# City of San Antonio, Texas

Department of Development Services

Re: Silverado Hills II Master Development Plan **M.D.P. # 019-06**

The City Staff Development Review Committee has reviewed the Silverado Hills Subdivision Master Development Plan **M.D.P. # 019-06**. Please find enclosed a signed copy for your files. Your plan was approved for acceptance however please note the following conditions:

MASTER DEVELOPMENT PLAN  
SILVERADO HILLS II  
CITY OF SAN ANTONIO, BEXAR COUNTY, TEXAS

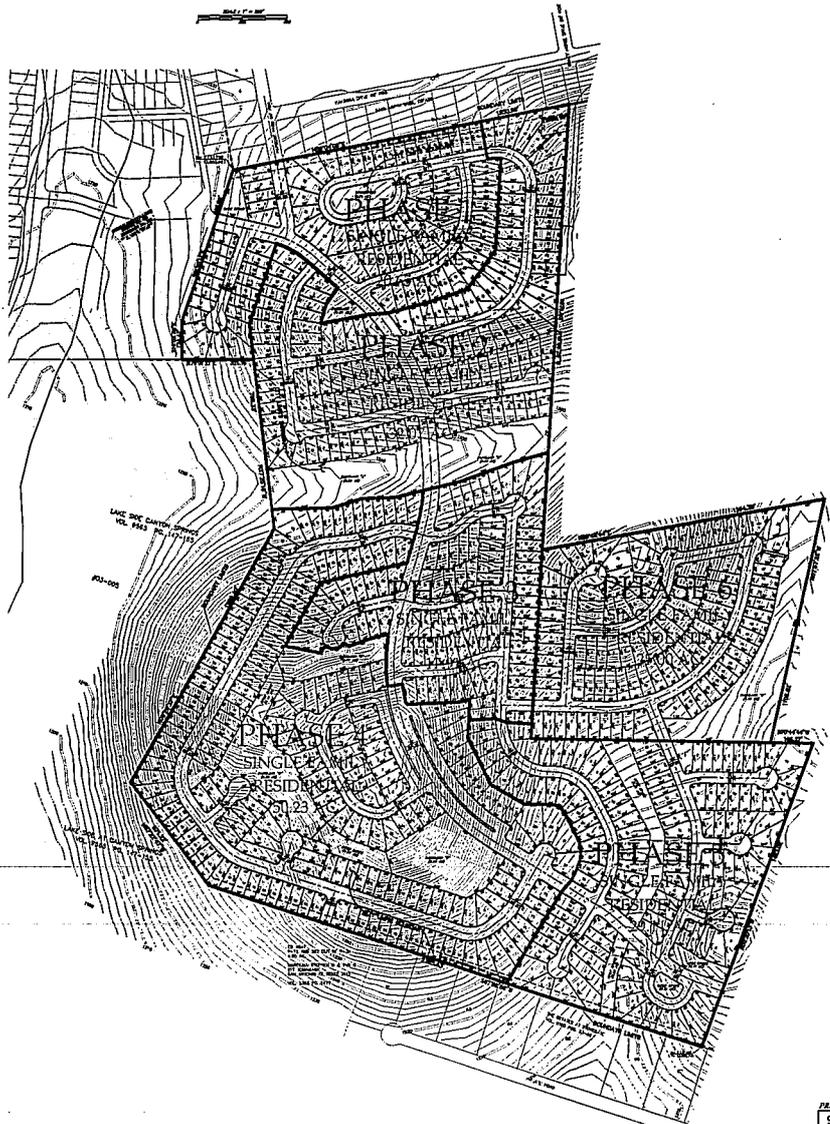
In consideration of public safety and convenience, excessive grades by reason of topography should be avoided in street layouts and arrangements. Any access and R.O.W. issues along state facilities will need to be resolved with the **Texas Department of Transportation (TXDOT)**. For information about these requirements you can contact TXDOT at 615-5814.

- ~~The parkland provided is dedicated to the Home Owners Association.~~
- A Provision and Maintenance Plan is provided to this department at the time of platting.

- Parkland dedication must be platted by the second phase of development.

- All roadways shall follow Table 506-7, Functional Classification System Description and shall comply with UDC 35-502(a)(9).
- All access roadways shall provide clear sight distance on all existing and proposed roadways in order to provide adequate obstruction free viewing distances for approaching traffic. All signage, landscaping, and improvements shall be selected and located so as to not block these clear sight distance areas.
- Sidewalks along all interior and exterior roadways are to be installed in accordance with UDC 35-506(q).

- Streetscape standards per UDC Section 35-512 - The new ROW (collector) will require streetscaping as well (we recommend preservation of existing trees where available and possible).

- Traffic controls shall be warranted as per the Texas Manual on Unified Control Devices and approved by Bexar County.
- The collector roadway within this subdivision will require a minimum of 44 feet of pavement marked with four lanes. Therefore, off street bike paths or additional pavement for bike lanes may be required.
